**Parks, Recreation,  
and Historic Preservation**

August 18, 2021

Re: ORES  
Garnet Energy Center Solar / 200 MW / 1,899 Acres  
Town of Conquest, Cayuga County, NY  
20PR03795

We have reviewed the Phase IB Archaeological Survey report prepared by TRC (Riccio et al. June 2021; 21SR00367). OPRHP understands that three (3) archaeological sites were identified during the archaeological survey. OPRHP has made the following determinations:

Figure 5-5. TRC-GAR-1 Site Avoidance Plan shown on 6/1/21 Civil Site Plan.

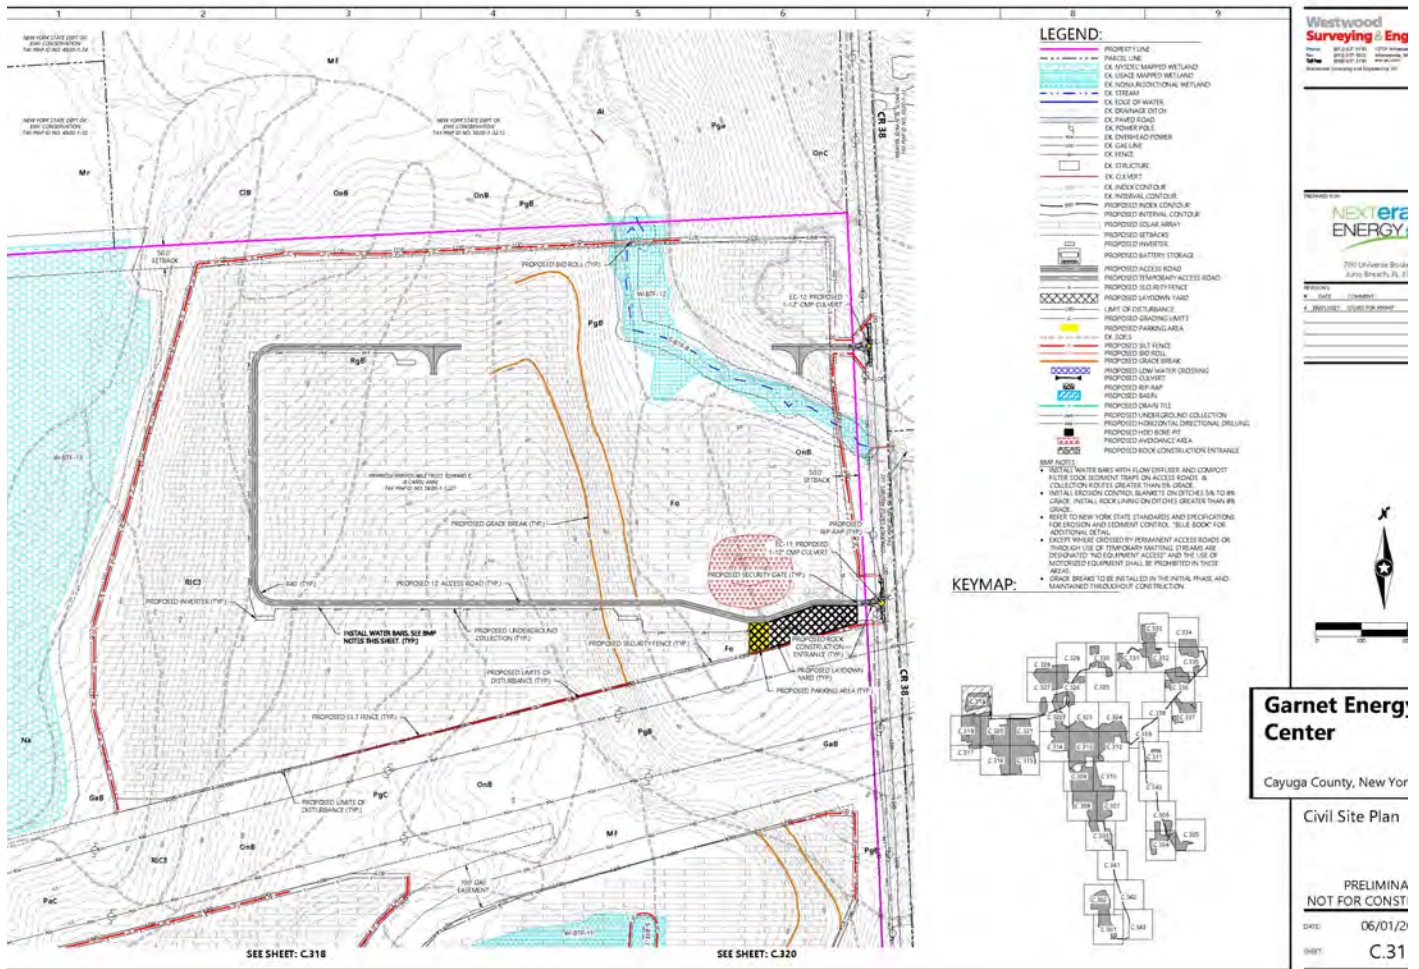
1. TRC-IF-2 (Indigenous) Site (USN 01104.000088) is not eligible for the State and National Registers of Historic Places (S/NRHP).
2. The eligibility of TRC-GAR-1 (Historic) Site (USN 01104.000086) and TRC-GAR-2 (Historic) Site (USN 01104.000087) remain undetermined. Both of these sites, including a fifty (50) foot buffer around them, are to be avoided as per the report's stated Site Avoidance Measures and Plans, and as detailed in the attached figures.

It is, therefore, OPRHP's opinion that this project will have no adverse impact on archaeological and/or historic resources listed in or eligible for the New York State and National Registers of Historic Places *with the condition* that the stated Avoidance Measures and Plans are implemented. This recommendation pertains only to the Area of Potential Effects (APE) examined during the above-referenced investigation. Should the project design change, the SHPO recommends further consultation with this office.
